SUBJECT: Forwards responses to questions raised re fire protection analysis.Diesel generator room drawings encl.

November 29, 1979
LDR-79-326

QUESTIONS AND ANSWERS CONCERNING
THE
DUANE ARNOLD ENERGY CENTER
FIRE HAZARD ANALYSIS

Diesel Generator Rooms
Proposed Sprinkler System
addition (Item 5)

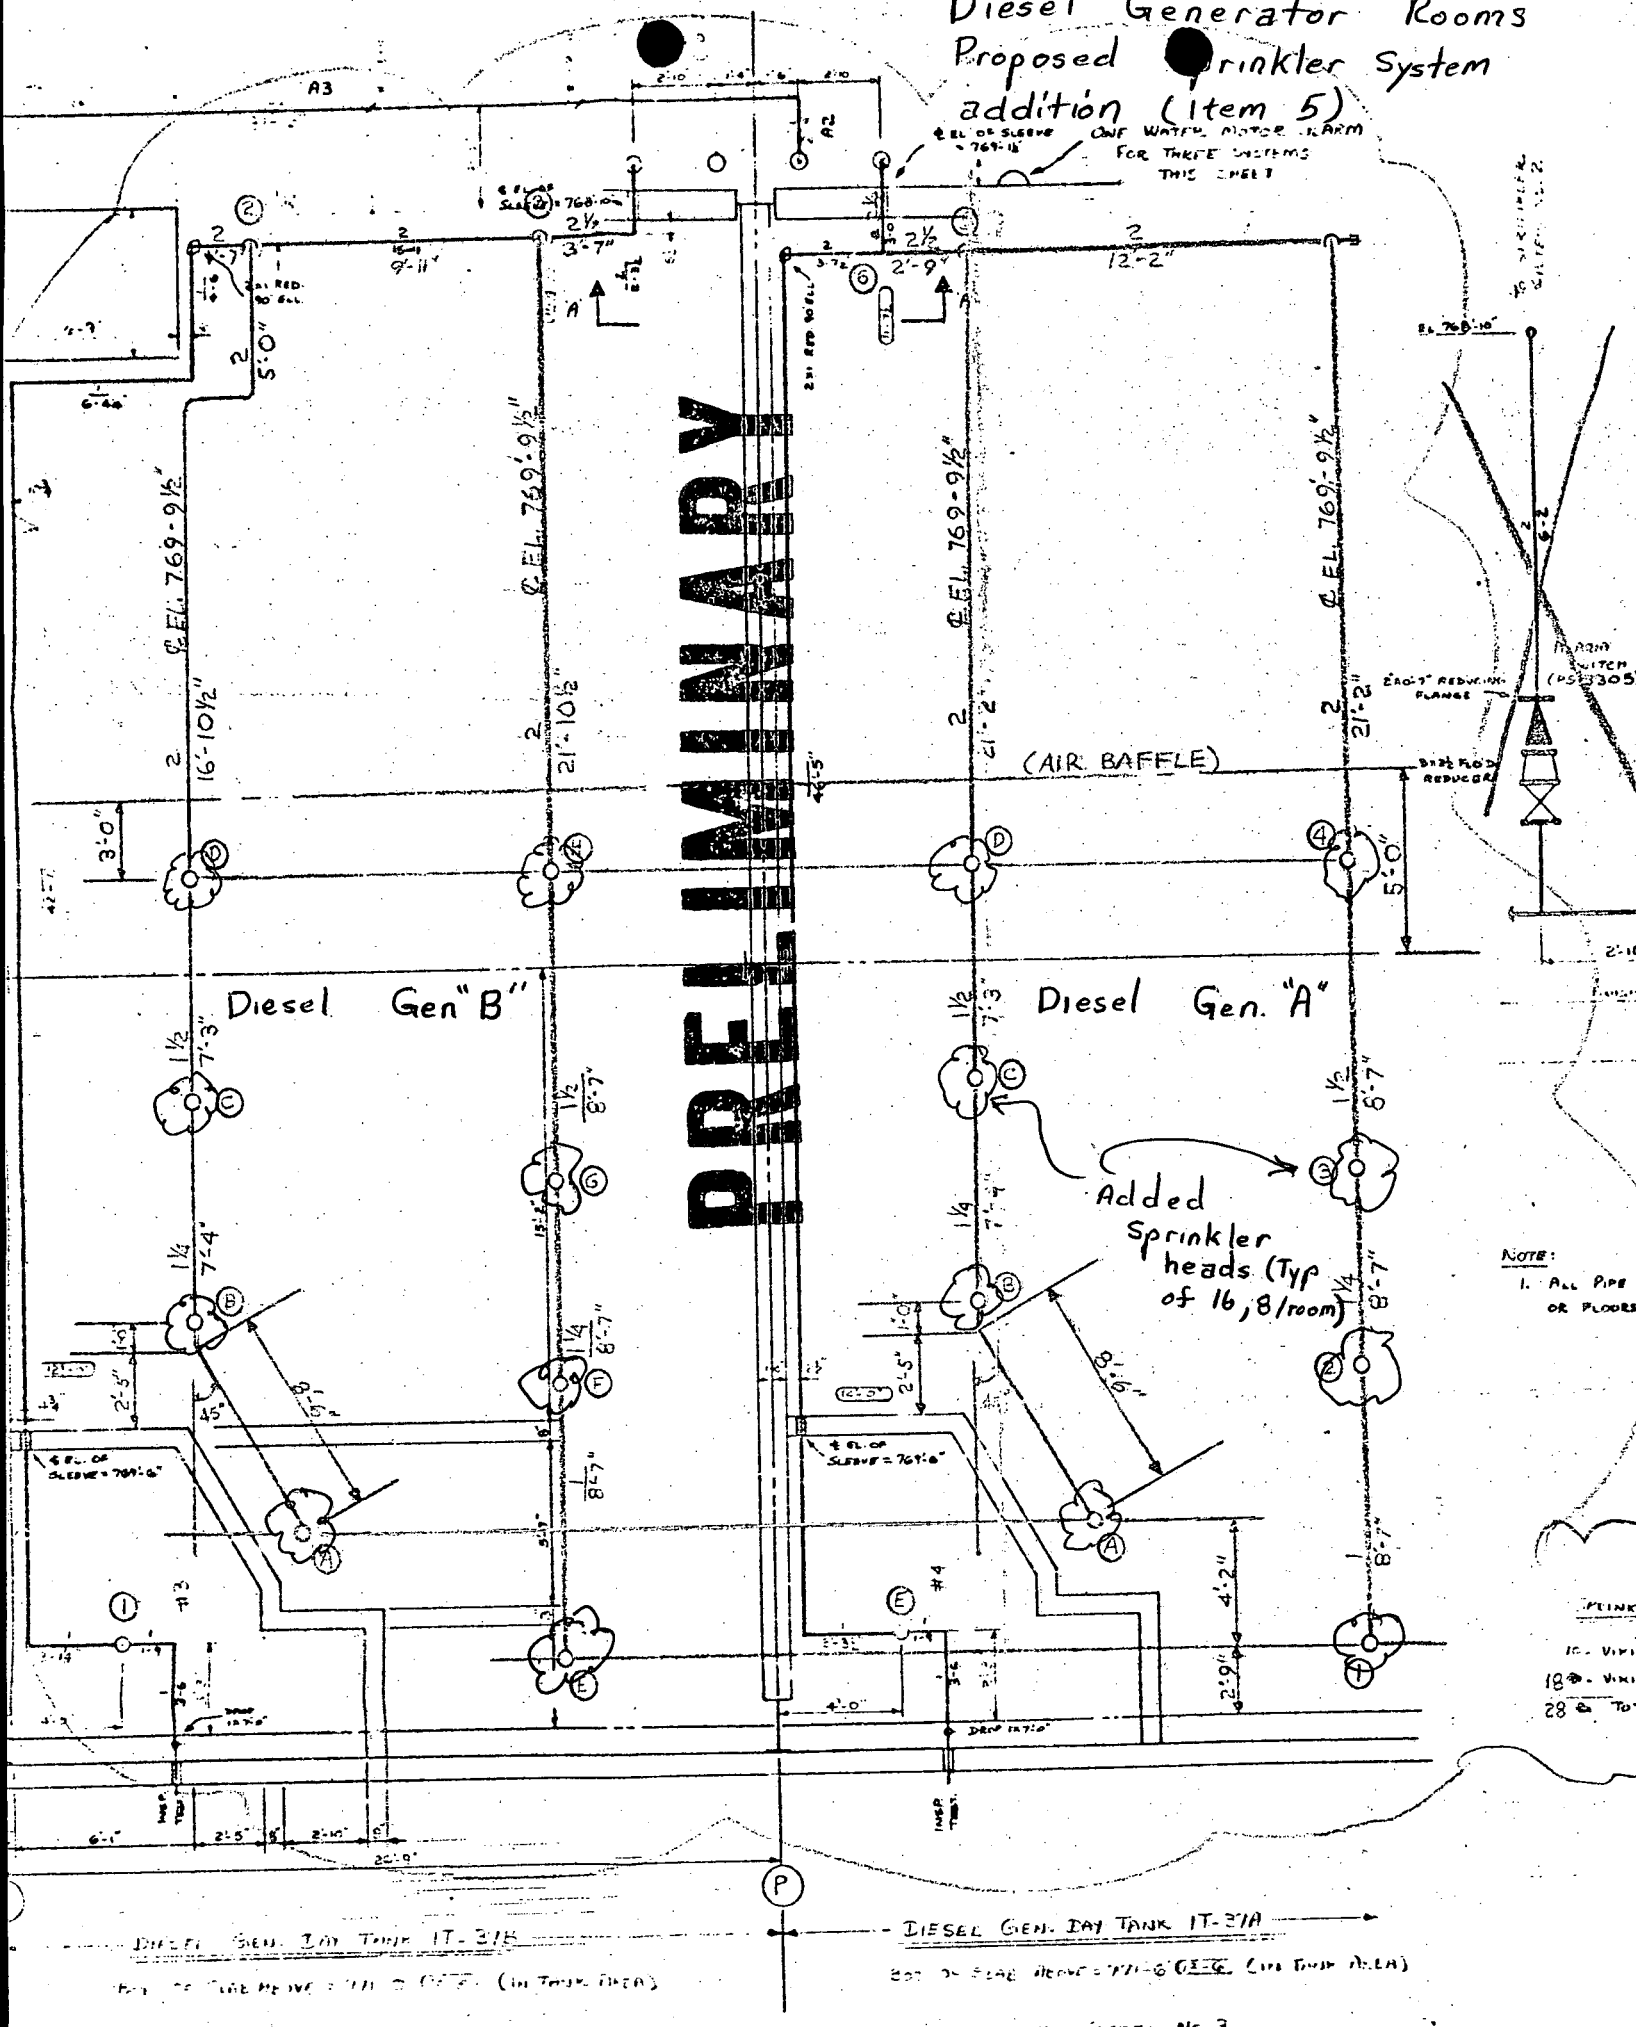
5. Drawings that we provided for the Emergency Diesel Generator Room were only plan views. They would like to see sprinkler layout drawings and would like information on system coverage densities, type of detection, and system trip points.

Attached is a preliminary sketch of the proposed sprinkler layout. This sketch is only a guide used for design calculations. The contractor will be required to finalize the design. A coverage density of 0.30 gpm/ft^2 is required. The system will have a rate of rise release to put water into the sytem prior to fusing of the sprinkler. It is estimated that 8 additional 1/2" upright spray sprinklers will be added to each room but actual numbers will be dependent upon contractors final design.

Diesel Generator Duct Revision (Item 6)

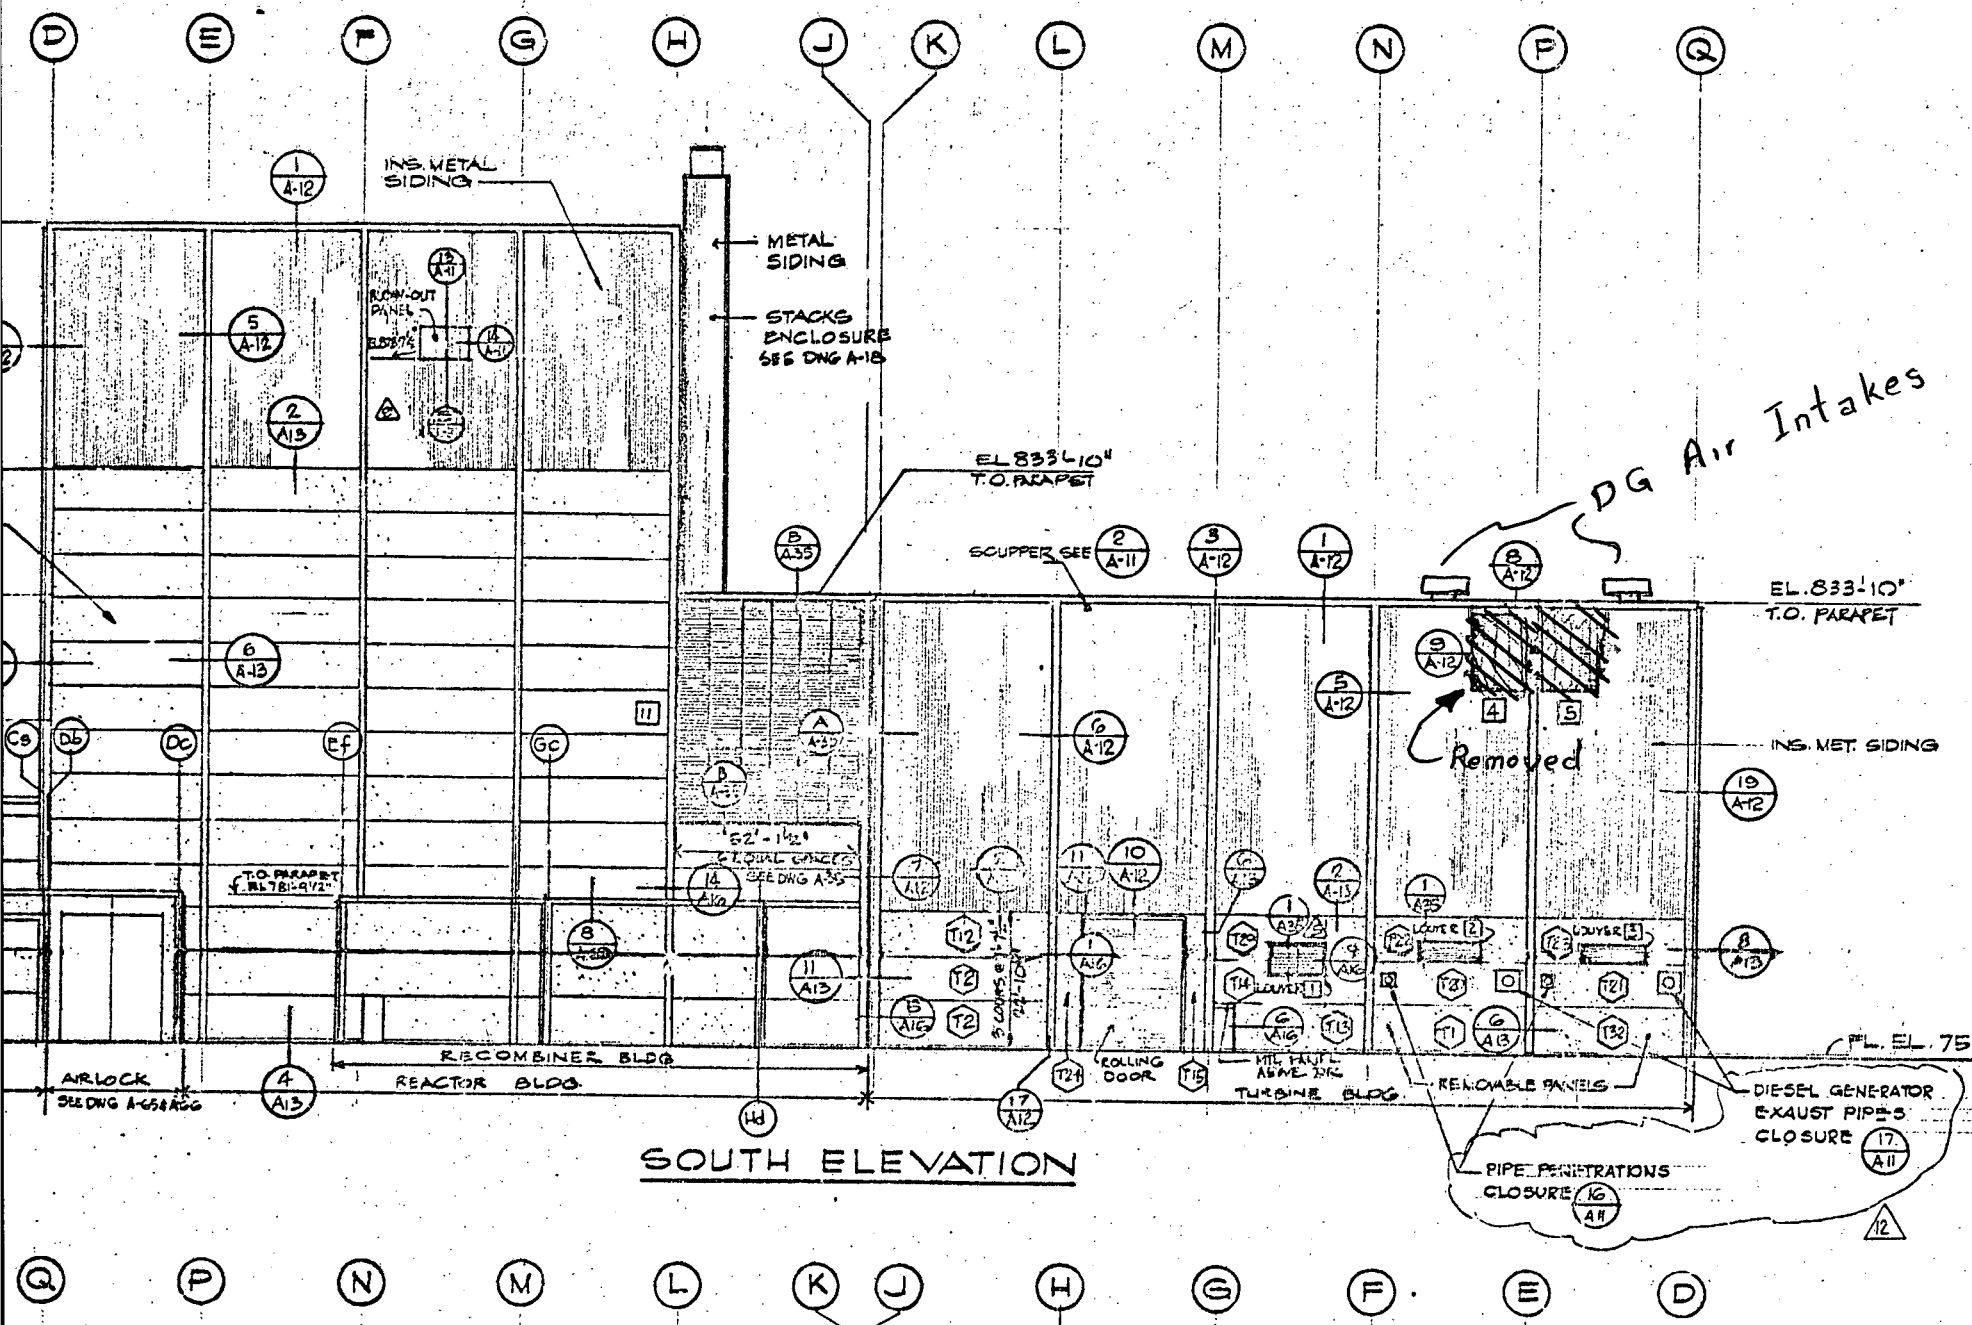
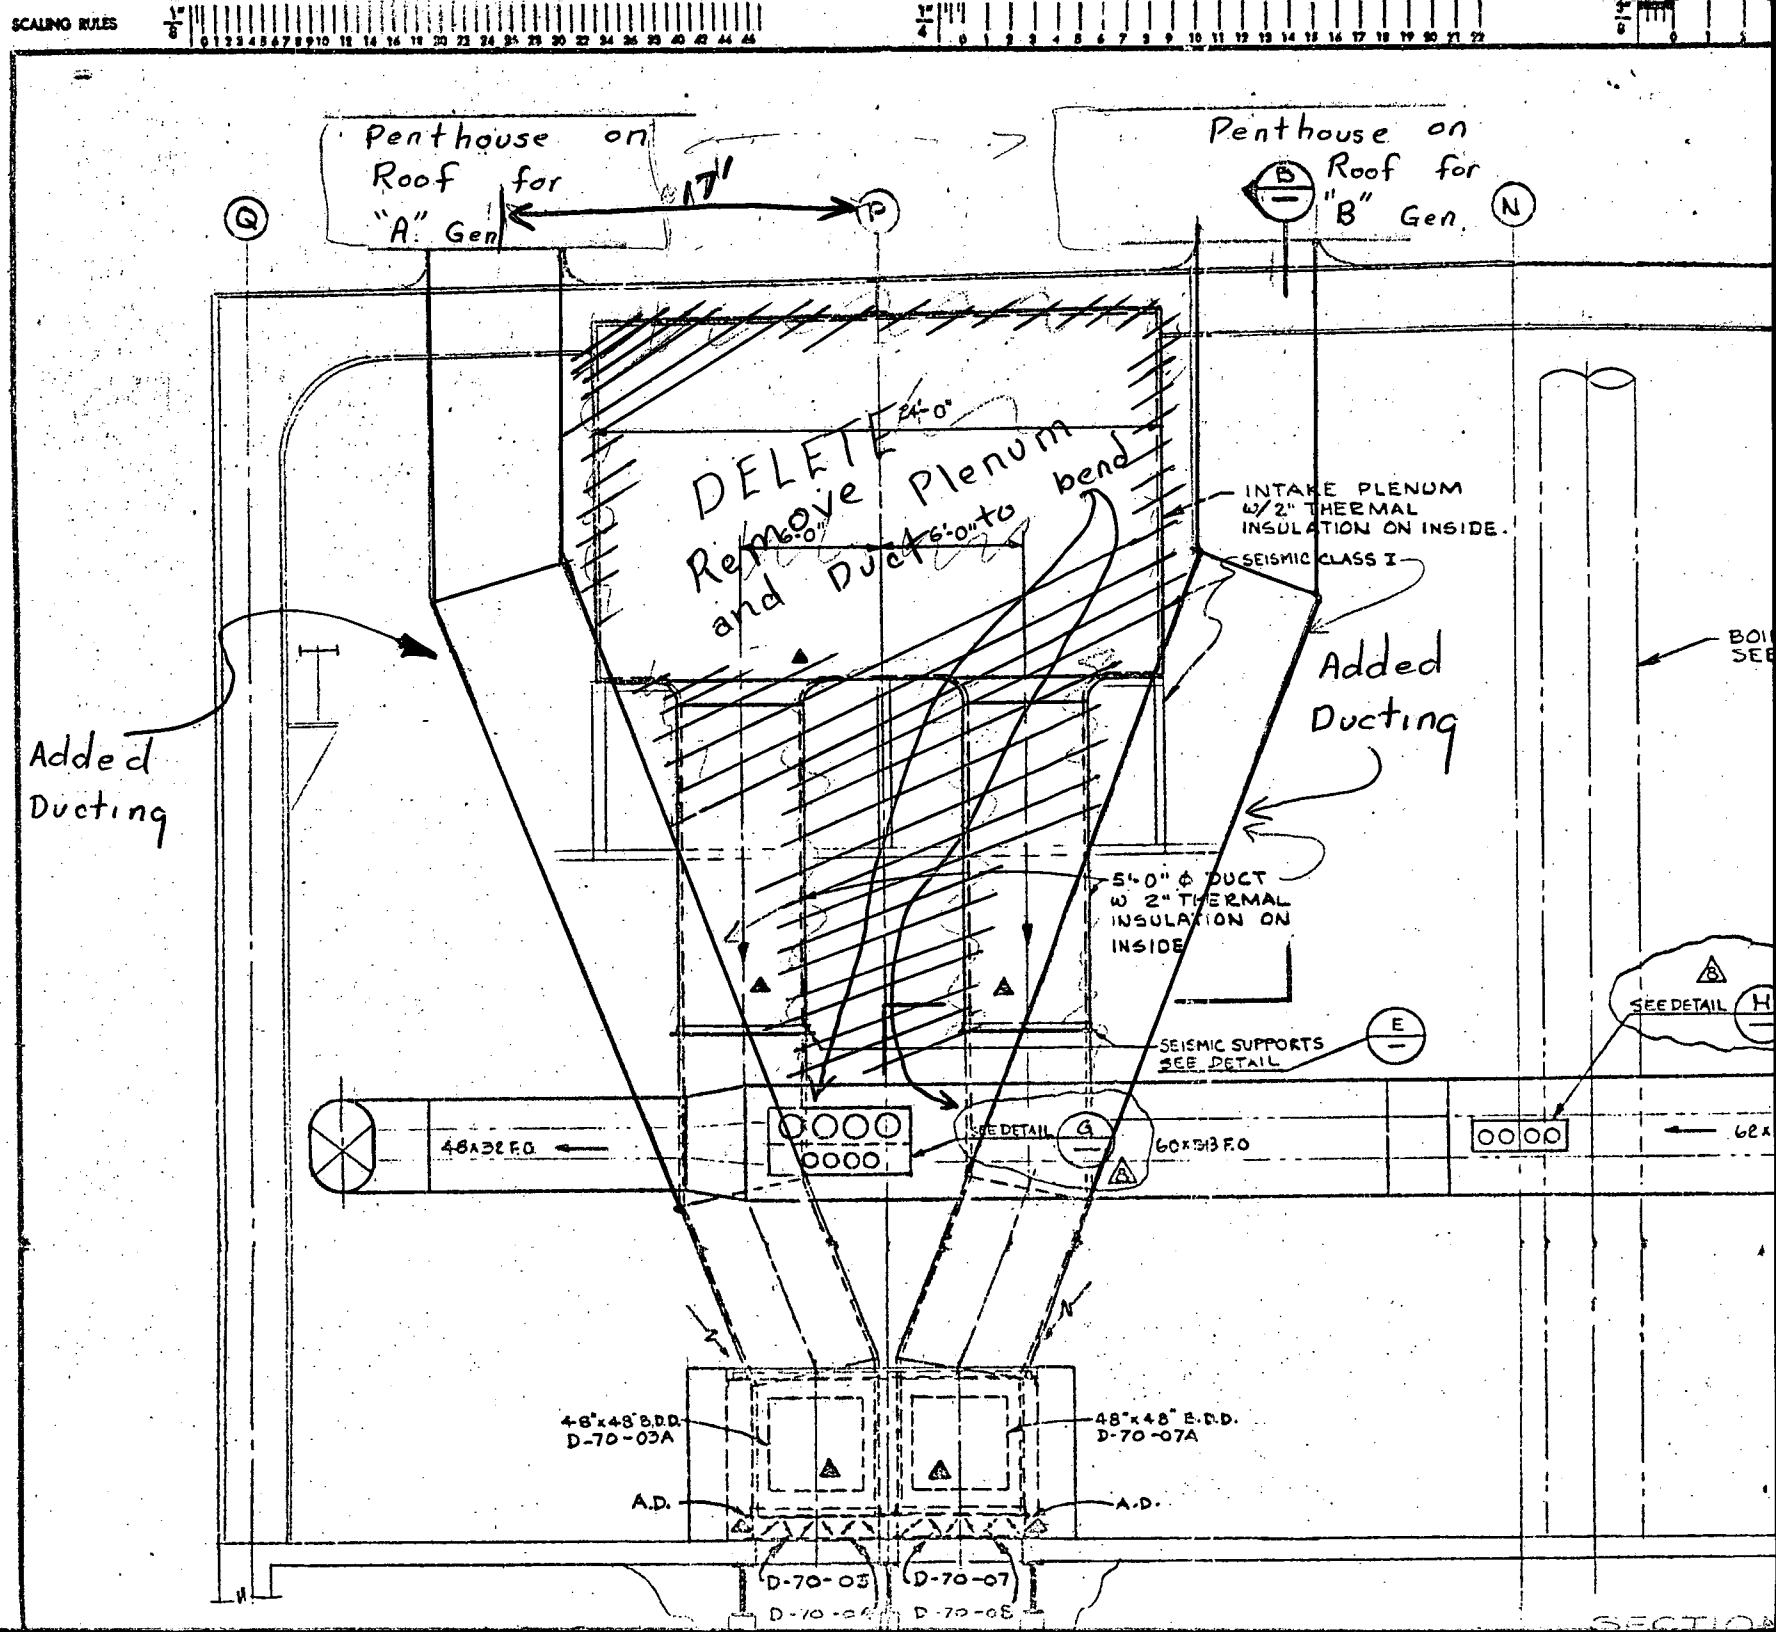
6. A question remains concerning our analysis and design modifications for air intake into the Emergency Diesel Generator rooms.

Please see the attached drawings which show how we intend to take intake suction from above the Turbine Building roof.
